RESPONSE TO SUBMISSIONS REPORT

The New Primary School in Mulgoa Rise - SSD-11070211

17 November 2021

Figure 7 – Bus Zones at Pedestrian Holding Area

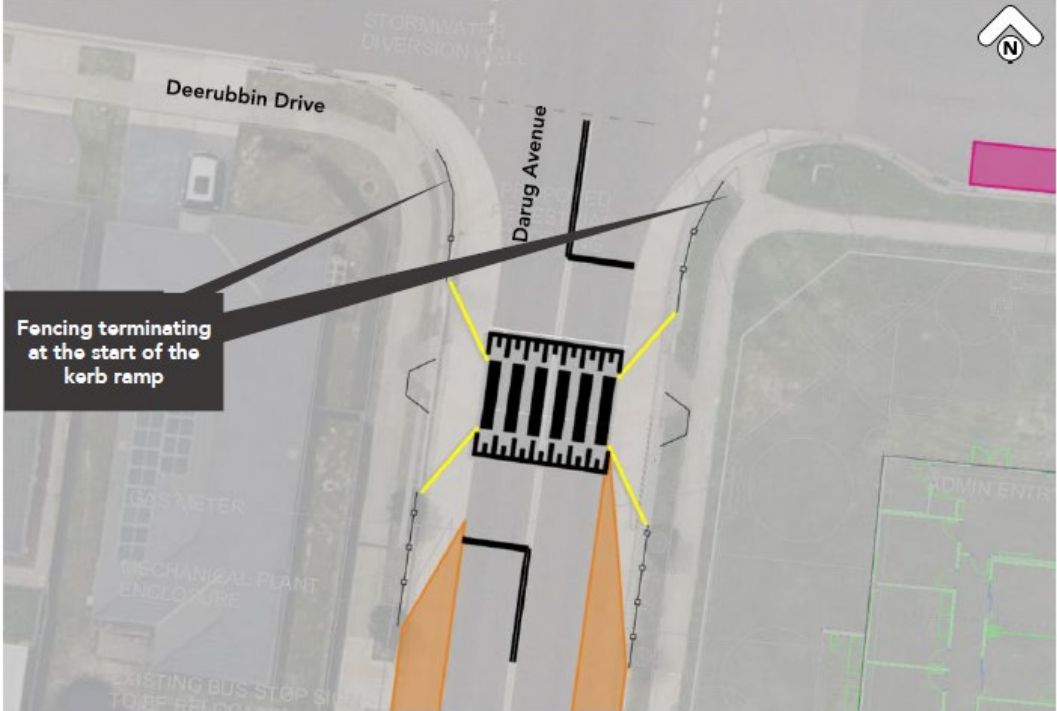
Comment/Issue	Response
	b. Bus zone signage has been proposed as part of the SSDA submission, refer to the Transport and Traffic Assessment. The amended signage plan is presented in Attachment 1 of Appendix E. c. It is not proposed to relocate the boarding point on the western side of Darug Avenue, as there is no requirement to do so. Refer to Section 2.2 for the relation between the zebra crossing and the bus stops. The eastern boarding point has already been addressed in the SSDA TTA, where it was relocated south by 5m due to the zebra crossing design. The location of existing bus stops and boarding points at Darug Avenue are presented in Figure 7.

Figure 10 – Proposed Zebra Crossing Design

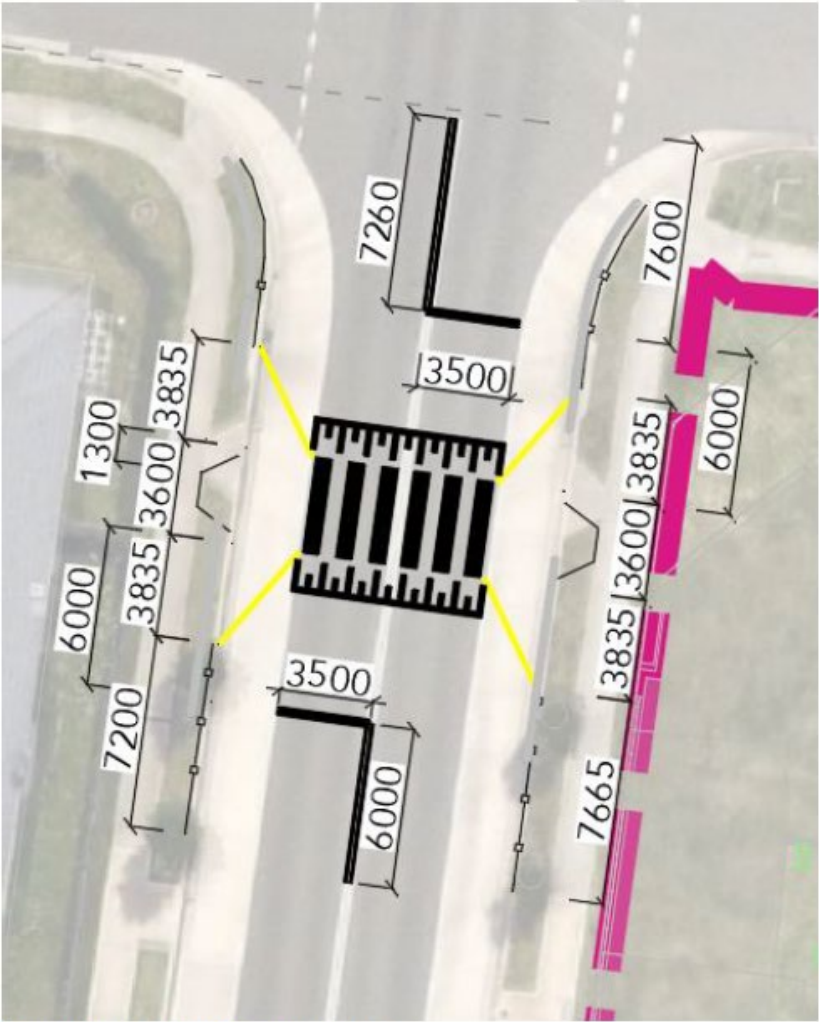
Comment/Issue	Response
c. The raised combined pedestrian / children's crossings are to be provided in the proposed pedestrian crossing locations in the fronting streets, including Deerubbin Drive in the first stage of this development. d. The proposed at grade pedestrian crossings must be raised and conform to Council's general design for raised combined pedestrian / children's crossings. The crossings must be a combined raised pedestrian crossing and children's crossing with raised shoulder medians, no fencing on the shoulders as shown proposed, with red and white poles, approach TF holding lines, children crossing flags and No Stopping zones complying with TfNSW guidelines. e. There should also be pedestrian fencing provided on the verge at the back of the kerb, at the crossing 'No Stopping' zones on each side to direct pedestrian to the crossing. f. The proposed crossing in Darug Avenue and in Forestwood Drive should be relocated to provide at least 13m of queuing clearance (to allow for two cars or one HRV or bus) from the Deerubbin Drive and Forestwood Drive through traffic to the TF holding line which should be located 6m from the edge of marked pedestrian crossing. g. The 'No Stopping' zones and traffic controls at the proposed combined raised pedestrian / children's crossing shall comply with AS 1742 and TfNSW Supplement to Australian Standards As 1742 including TfNSW Technical Direction TDT 2002/12c. h. The proposal should include the provision of street lighting at all pedestrian crossings that complies with Australian Standards. Details should be submitted for assessment or this should be addressed via conditions of consent, to the satisfaction of Council as the relevant roads authority. i. An amended application shall include the provision of a continuous footpath treatments across the school driveways to highlight to motorists that pedestrians have right of way when walking on the footpath/driveway.	 Figure 8 – Proposed Signages at Forestwood Drive and Parkway Avenue bend b. The fencing at the corner of Darug Avenue and Deerubbin Drive has been amended to terminate at the start of the kerb ramp, as shown in Figure 9. A detailed amended signage plan is presented in Attachment 1 of Appendix E and illustrates the extent of works within the public domain.

Figure 14 – Vehicle Holding Area at Darug Avenue

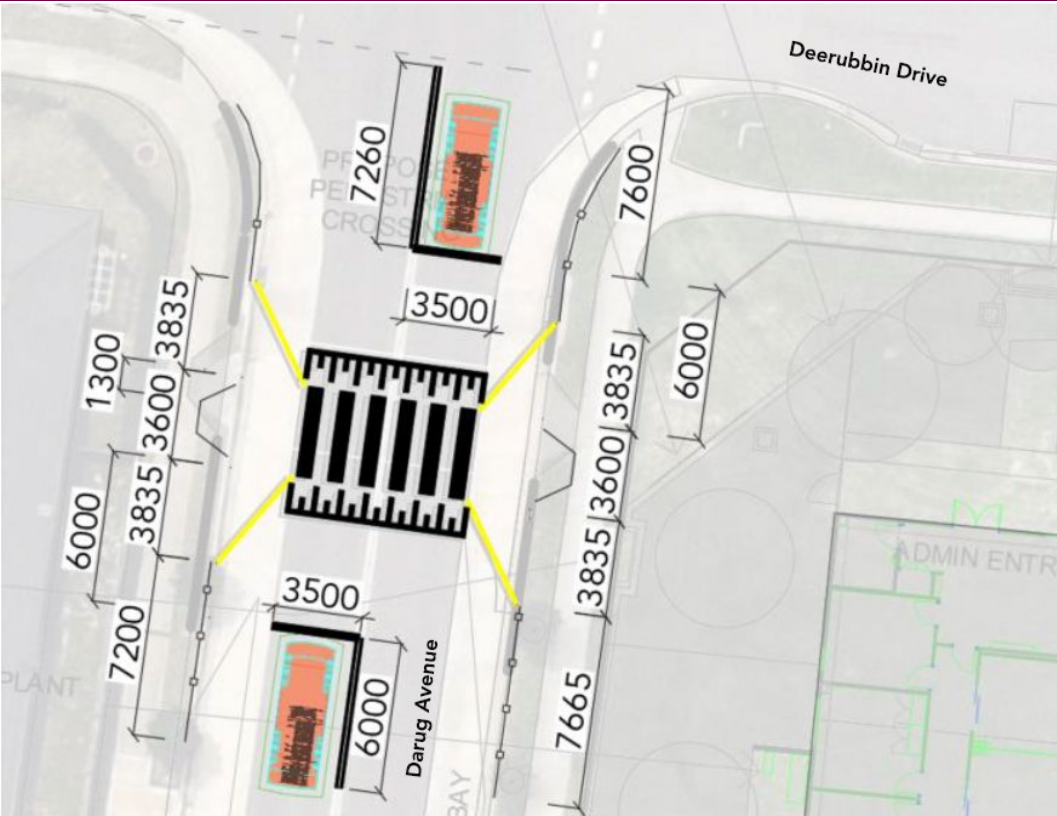
Comment/Issue	Response
	9.4 Pedestrian fencing Fencing may be used at the kerb side to direct pedestrians to a crossing point and to prevent pedestrians from crossing at other nearby points. It discourages motorists from parking close to a crossing point. Fencing may also be used on medians and loading islands to control pedestrian movements. When used at staged crossings, it should be so aligned that pedestrians will face oncoming traffic as they are about to leave the median. Particular attention should be given to the height and placement of the fence, and to the material used in its construction so as to minimize the potential sight obstruction between drivers and children about to cross the road. Fence material and construction should also be such as to minimize injuries to road users in the event of a collision. The risk of the fence preventing exit from a vehicle parked close to it needs also to be assessed. Fencing is proposed on the verge at the back of the kerb from the zebra crossings to the pram ramps at intersections, from zebra crossings to 'No Stopping' or a distance of 7.5m at the midblock, at the start or end of bus bays and up to the driveways of the adjacent properties. The proposed fencing at Darug Avenue, Deerubbin Drive and Forestwood Drive are presented in Figure 11, Figure 12 and Figure 13 respectively. f. The zebra crossings have been relocated following the detailed design and they are now located as follows (refer to Figure 14 and Figure 15): ○ 7.6 m long vehicle holding area is provided on Darug Avenue allowing for 1 car to wait, and ○ 14.7m long vehicle holding area is provided on Forestwood Drive allowing for 2 cars or 1 truck to wait. ○ Additional 6m distance from the zebra crossing to the stop line is provided at both crossings, as per the guidelines for children's crossing. Lengthening the distance of the Darug Avenue crossing to a distance of 13m from the intersections is not seen as required and is not recommended for the following reasons: ○ The crossings would be moved away from the pedestrian desire lines, which would in turn likely result in more pedestrians crossing the roads unsafely closer to the intersections. ○ Existing bus stops on either side of Darug Avenue would need to either be removed or relocated further south, which is not feasible for the bus route going northbound. ○ It is expected that only the occasional truck, if any, would travel during the pick-up and drop-off times. ○ There is no guideline or standard that prescribes an offset of a zebra crossing from an intersection. The project proposes to locate the crossings at least 12m from the intersections to allow a 6m distance to a stop line plus a waiting space for 1 car, which is considered suitable. This design was accepted by Council and TfNSW during the Transport Working Group meeting held on 3rd November 2021.

Refer to the above sections for details regarding ‘No Stopping’ zones and **Attachment 1** of **Appendix E** for detailed drawings.

Figure 18 – Bus Bays at Darug Avenue

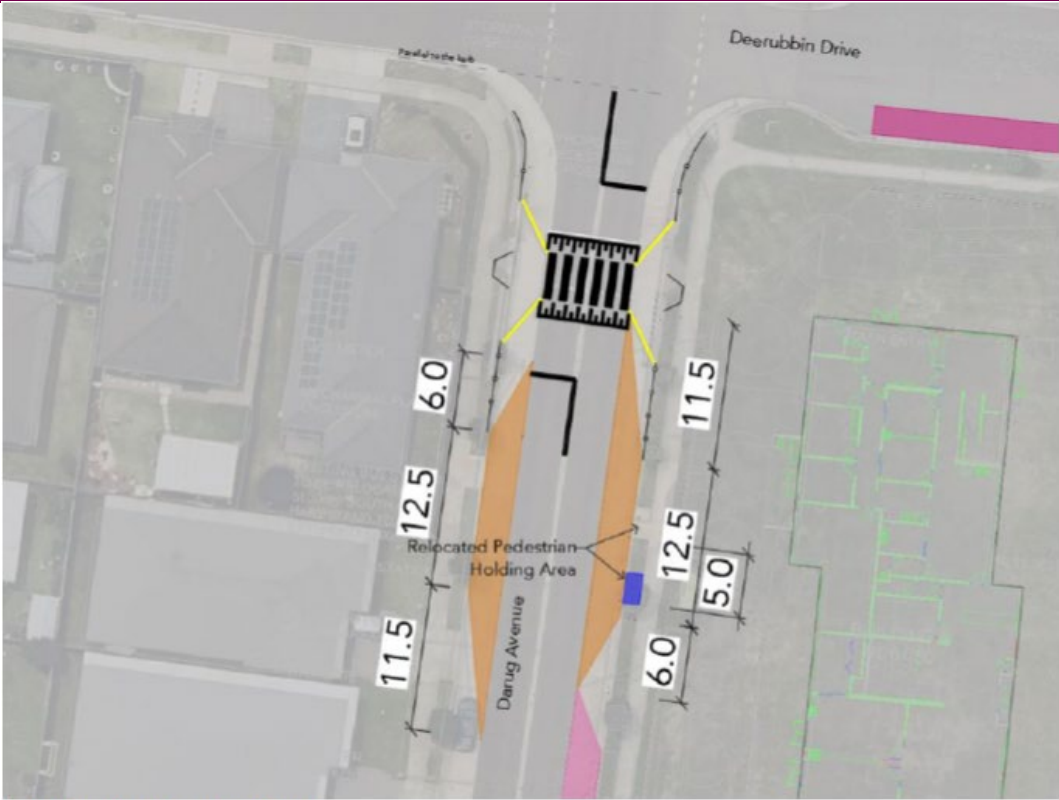
The proposed zebra crossing and the proposed relocated eastern bus bay have been located such that both bus bays at Darug Avenue will be compliant with the TfNSW requirement, thus will meet the minimum requirement for parking, draw-in and draw-out lengths, as shown in the figure below.	Minimum Bus Draw In and Draw Out Lengths					Type of bus	Length (metres)	Min. draw-in length (metres)	Min. draw-out length (metres)	Length for one bus (metres)	Standard (inc double decker)	12.5	11.5	6.0	30.0	Long Rigid	14.5	14.0	6.5	35.0	Articulated	18.0	14.0	8.0	40.0
Minimum Bus Draw In and Draw Out Lengths																										
Type of bus	Length (metres)	Min. draw-in length (metres)	Min. draw-out length (metres)	Length for one bus (metres)																						
Standard (inc double decker)	12.5	11.5	6.0	30.0																						
Long Rigid	14.5	14.0	6.5	35.0																						
Articulated	18.0	14.0	8.0	40.0

Comment/Issue	Response
	 An aerial photograph of Darug Avenue showing proposed bus bays and pedestrian holding areas. The image includes several dimension lines: 11.5m, 12.5m, 6.0m, 11.5m, 12.5m, 6.0m, 5.0m, and 11.5m. A 'Relocated Pedestrian Holding Area' is marked with a blue rectangle. A zebra crossing is shown with a black and white striped pattern. The street is labeled 'Darug Avenue' and 'Deerubbin Drive'.

Figure 22 – Sight distances as loading area access

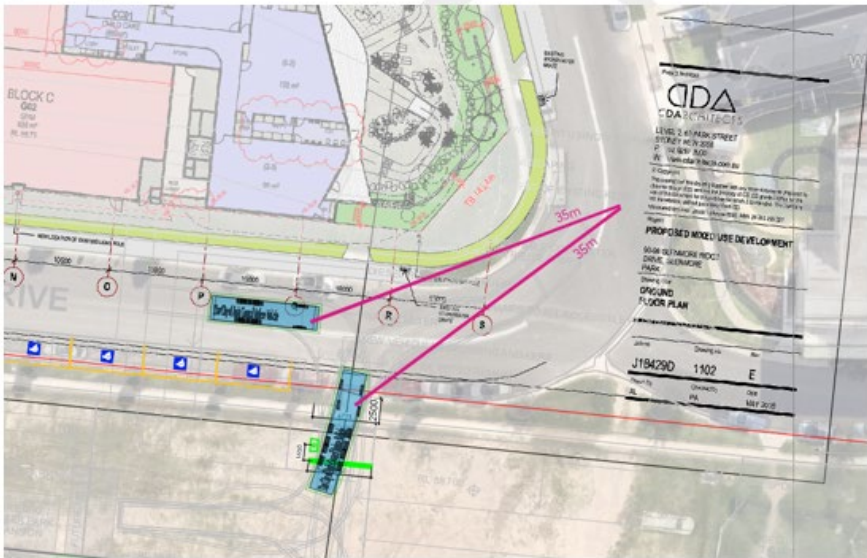
o. Attachment 3 – Figure 81 shows a surface change at a raised intersection (which does not have pedestrian priority). Is there justification as to why a surface treatment is being considered as an isolated treatment at crossings? Surface treatments are generally used as a threshold treatment or to highlight the presence of something. Zebra pavement markings already indicates the pedestrian priority at crossings, addition surface treatments may detract from the zebra pavement marking;	The change in pavement was proposed to imitate a raised crossing / shared zone to raise driver's awareness of an increased pedestrian activity. This is because the development cannot provide a raised zebra crossing due to flooding issues. A discussion on the zebra crossing design ins provided in Table 4 on the proceeding pages.

- The sight lines have been shown to be sufficient, given the expected speeds at this section of the road.
- This driveway will be used by waste and delivery vehicles only, thus the frequency will be low.

Figure 23 – AV Swept Path at Bradley Street / Darug Avenue intersection

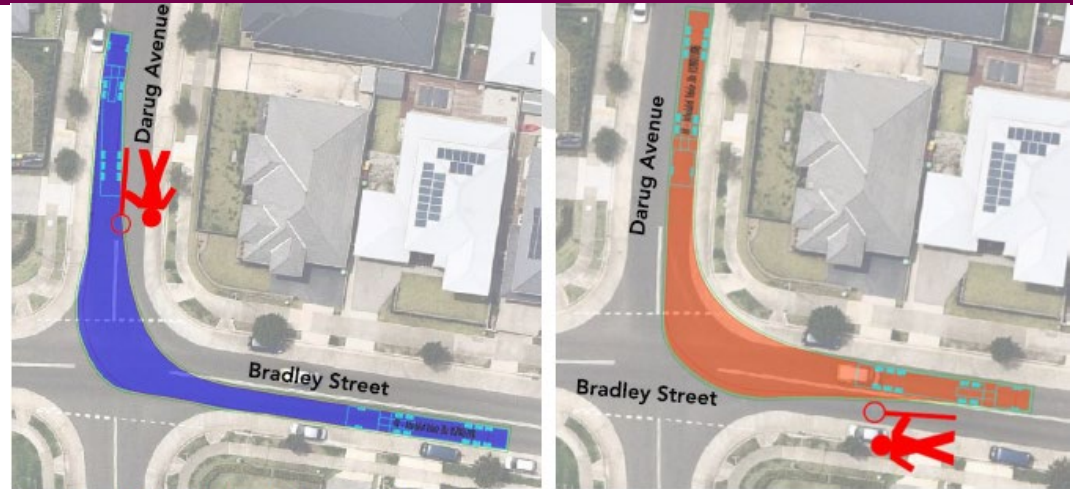
Preliminary Construction Traffic and Pedestrian Management Plan (PCTPMP)	
a. 5.6.2 / Figure 23 – traffic controllers would be required to stop traffic in both directions on Darug Avenue, the plan should be updated to reflect this;	A truck turning right into the site and a truck exiting the site will need to give way to the southbound traffic, which does not create any conflicts. Nevertheless, a traffic controller can be provided on the northern side as requested. The CTMP can be updated at the Construction Certificate stage.

b. 5.6.2 / Figure 24 – Truck turning right requires to occupy the left side of the road, however it is still required to give way to vehicles travelling eastbound. This will cause issues as the truck would either be obstructing the entire westbound carriageway as it waits for an appropriate gap, or the left side of the road, which causes further issues for other traffic navigating this intersection. Traffic would be required to be controlled on all legs, as truck coming out of Darug Avenue is required to still give way to vehicles travelling east along Bradley Street. This arrangement is not supported and TfNSW requests that smaller construction vehicles are used to improve safe outcomes for road users.	The Bradley Street / Darug Avenue intersection discussed in the preliminary CTMP has been shown to accommodate 2 trucks travelling simultaneously. Based on the TfNSW comment, it is proposed that these two turn movements do not overlap, which can be controlled by traffic controllers. The truck exiting Bradley Street and turning right into Darug Avenue will need to give-way to the eastbound vehicles, which is a standard approach and as such, no conflict is seen between the vehicles travelling eastbound and the truck turning right. The right turn movement into Darug Avenue has been amended and a traffic controller has been provided to prepare the southbound traffic to stop. For the truck exiting Darug Avenue and turning left into Bradley Street, the truck will need to give-way to the eastbound vehicles, which is a standard approach. It is noted that the truck's left turn movement creates conflict with the westbound vehicles on Bradley Street; however, this will be managed by a traffic controller and is not unusual. The construction truck driver will be informed about the required traffic manoeuvres along the local roads, and therefore, this is not considered an issue. This was agreed during the TWG meeting held on the 3rd November 2021. The CTMP will be updated accordingly at the Construction Certificate stage.
